9 Nassington Road,
London, NW3 2TX

Basement Impact Assessment
Audit

For
London Borough of Camden

Project Number: 12985-57
Revision: D1

SK04

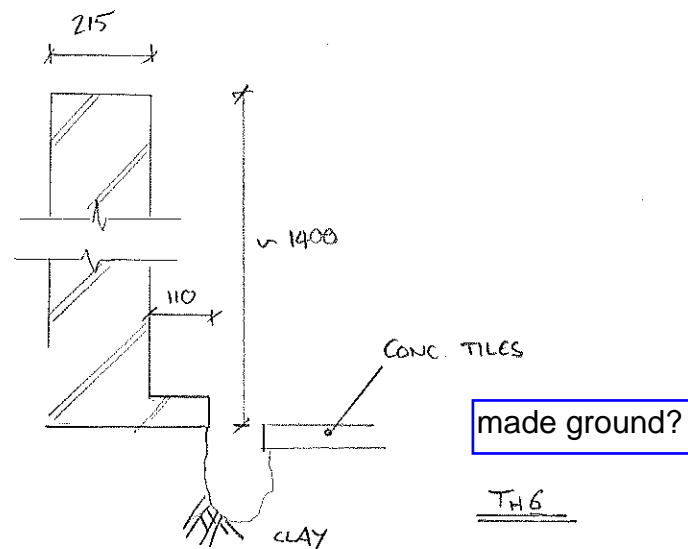
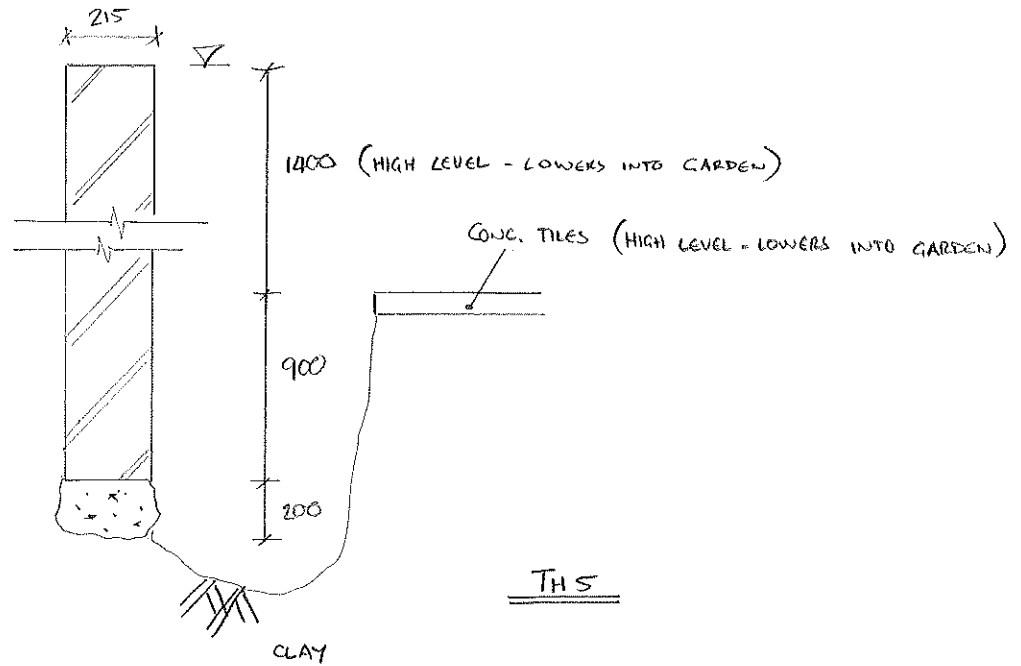
soil testing?

made ground?

perched water?
